Date May. 20th 2009
Ref.No. G2K-R-090513-1
Prepared R. Matsushita
Checked _____
Approved J. Ohawa
MIYOSHI Electronics Co.
RF devices dept

Subject: Notification of change tray for Mitsubishi Si RF Power modules.

● This picture shows the current tray and the new tray.

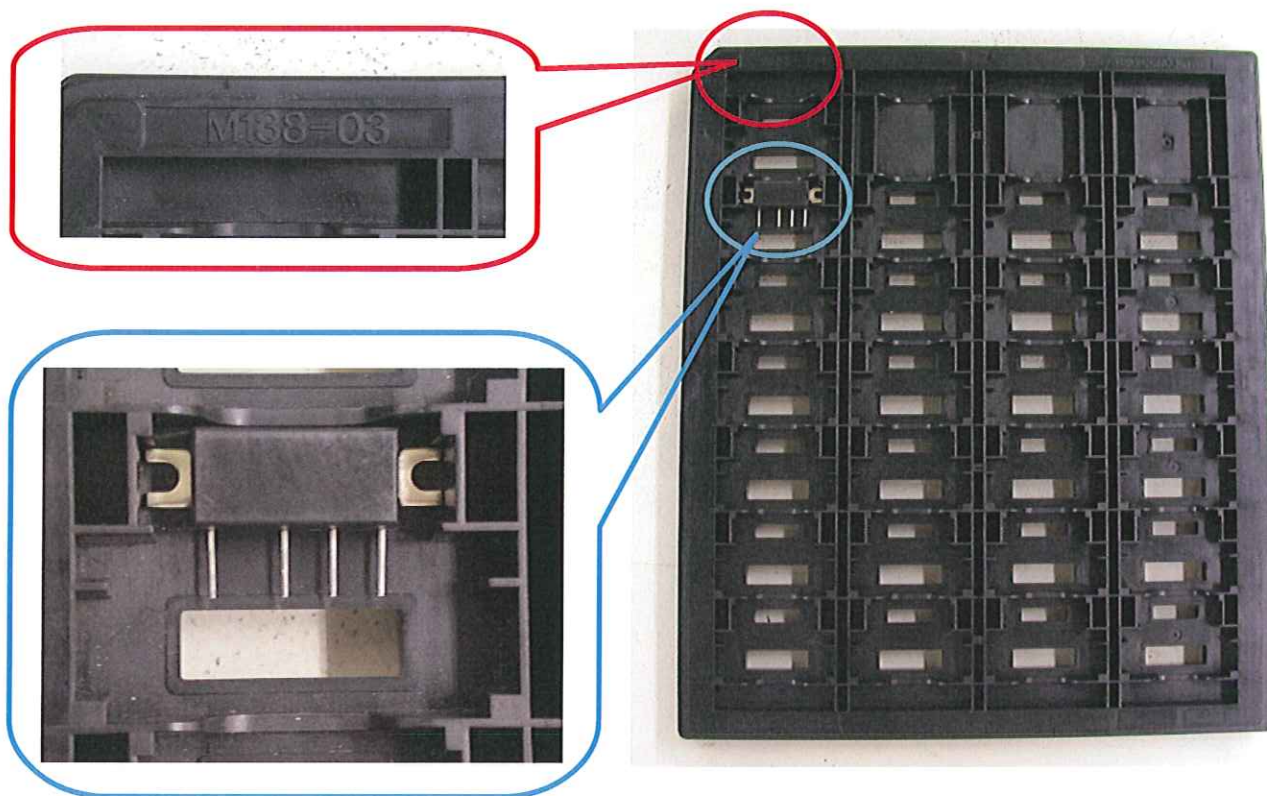
Contents	Current tray	New tray
Tray	Tray number	M138-03	M138-08
	One pocket dimensions	W: 42.5mm H: 29.0mm D: 7.0mm	W: 37.0mm H: 19.50mm D: 7.0mm
	One tray maximum amount	25pcs	50pcs
Packing box	The maximum amount of one packing box	400pcs	800pcs
	The maximum weight of one packing box	6.2kg	6.9kg

There are no change about materials and the outline dimensions of tray.

We are going to change new tray from production in September, 2009.
